PROPOSED CHANGE TO THE OPERATING LICENSE NPF-13  
PCOL-83/03

Mississippi Power & Light (MP&L) requests that the operating license for Grand Gulf Nuclear Station (GGNS)(NPF-13) be amended as detailed below. These proposed changes, as discussed below, are provided for Nuclear Regulatory Commission (NRC) review and approval per 10 CFR 50.90.

A. SURVEILLANCE PROCEDURE REVIEW - PACKAGE NO. 1, (ITEMS 1 THROUGH 32).

Bases Figure B 3/4 3-1  
REACTOR VESSEL WATER LEVEL

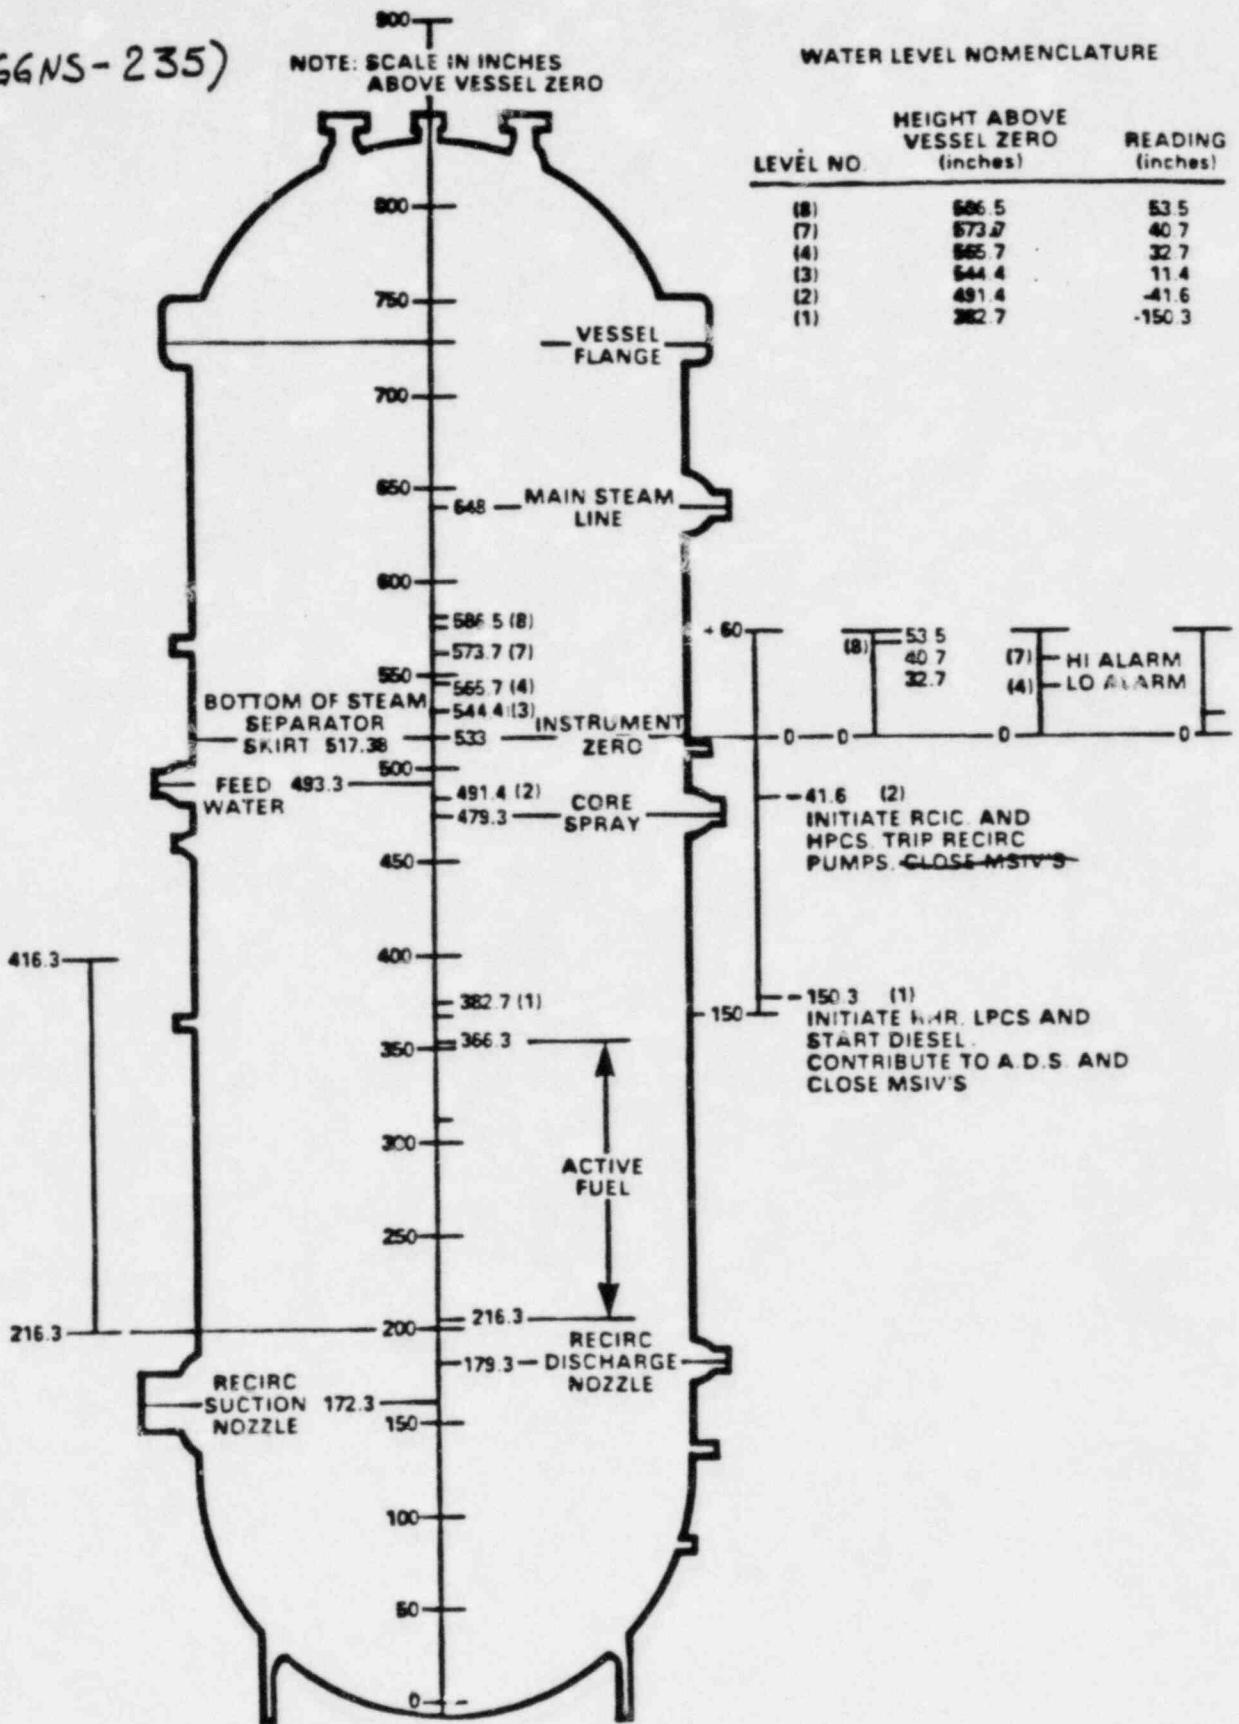
Bases Figure B 3/4 3-1 indicates MSIV closure at low, low level 2 (-41.6 inches) and also at low, low, low level 1 (-150.3 inches). The level 2 trip is incorrect and reference to MSIV closure should be deleted from the figure for level 2.

Technical Specification Table 3.3.2-2, Page 3/4 3-15 and FSAR Table 6.2-44 list MSIV trip setpoint to be low, low, low level 1 (-150.3 inches) as the correct trip setpoint.
